SECTION K: TECHNICAL, DESIGN AND OPERATIONAL CRITERIA AND PERFORMANCE REQUIREMENTS FOR OFFSHORE TRANSMISSION SYSTEMS

Figure K43

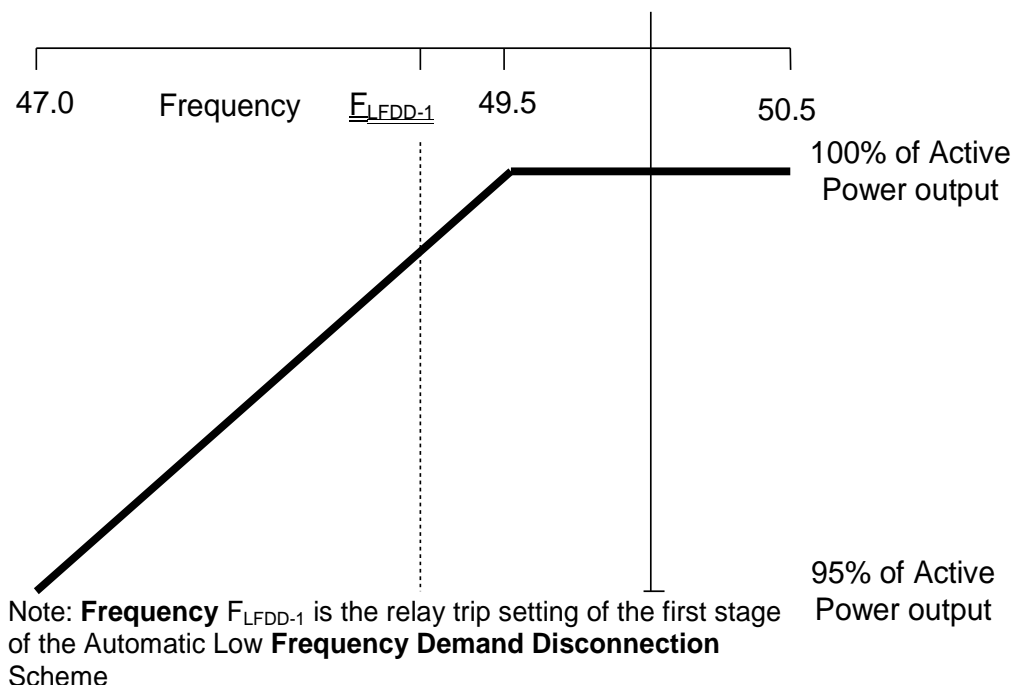
- (a) continuously maintaining constant Active Power transfer for System Frequency changes within the range 50.5 to 49.5 Hz; and
- (b) (subject to the provisions of Grid Code ECC.6.1.2) maintaining its Active Power transfer at a level not lower than the figure determined by the linear relationship shown in Figure K3 for System Frequency changes within the range 49.5 to 47 Hz, such that if the System Frequency drops to 47 Hz the Active Power transfer does not decrease by more than 5%.
